APPLICATION FOR PERMISSION
UNDER SECTION 16 OF
THE TOWN PLANNING ORDINANCE
(CAP. 131)

For Official Use Only 請勿填寫此欄	Application No. 申請編號	A/YL-NTM 1482
	Date Received 收到日期	2025-07-14

Temporary Public Vehicle Park for Private Cars and Associated Filling of Pond & Excavation of Land for a Period of 3 Years at Lots 1183 RP (Part), 1184 & 1185 RP (Part) in D.D. 104, Ngau Tam Mei, Yuen Long, N.T.

寄件者: king king <[REDACTED]>
寄件日期: 2025年08月28日星期四 21:04
收件者: tpbpd/PLAND
副本: Timothy Yuet Sang CHAN/PLAND
主旨: A/YL-NTM/482
附件: NTM482-ltr-03.pdf

Figure 2

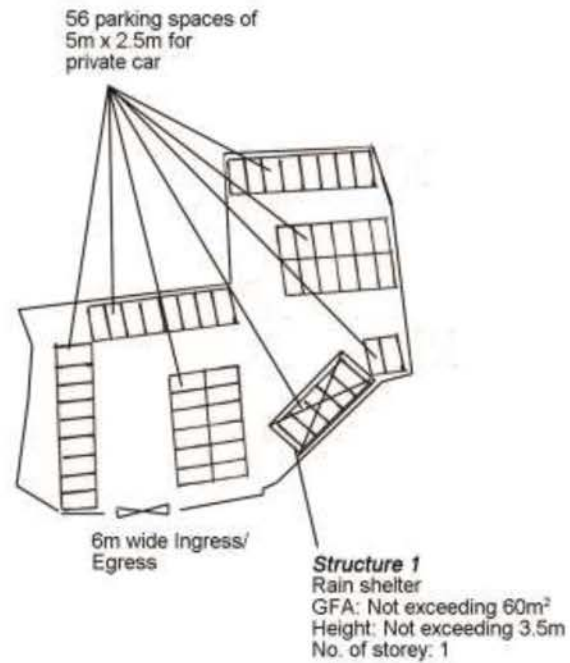
b) Based on the site layout plan, it appears that some of the parking lot cannot be utilized (such as the three nos. of parking lot next to the rain shelter). Hence, the applicant should critically review the parking layout and demonstrate the smooth manoeuvring of vehicles to / from the NTM Road and within the Site to the parking lot by providing swept path analysis.	Noted. The carpark is in actual operation so that it is demonstrated that the parking layout is feasible and there is smooth manoeuvring of vehicles to and from the Ngau Tam Mei Road and within the Site.

Figure 4

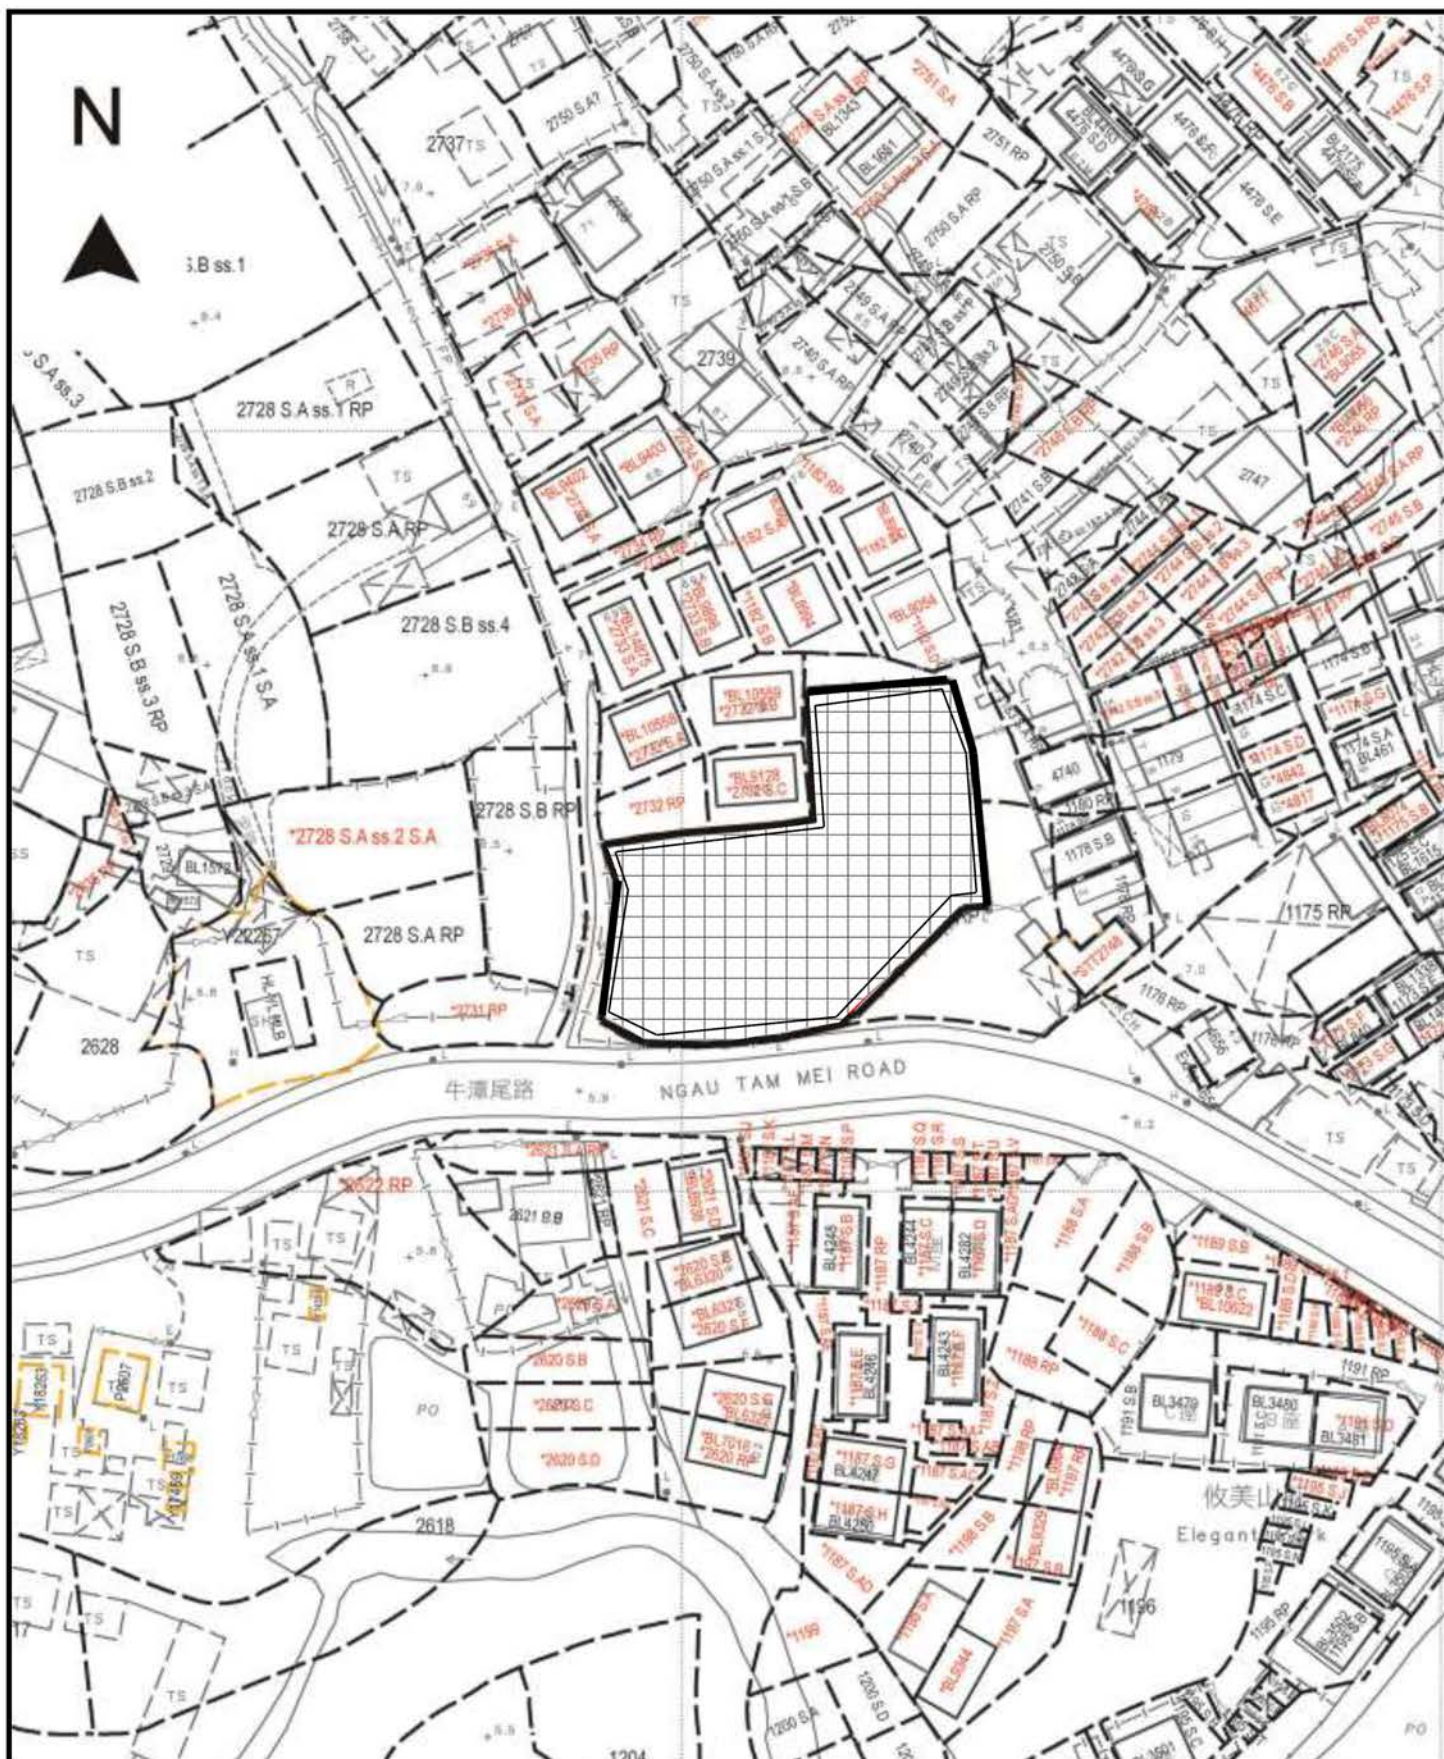
In addition, we found that there is a typo in page 6 of the S.16-III application form for the excavation of land. The area of excavation should be 65.25 sq. m. whereas the depth of excavation should be 0.375m to tally with Filling of Pond and Excavation of Land Plan in Figure 4.
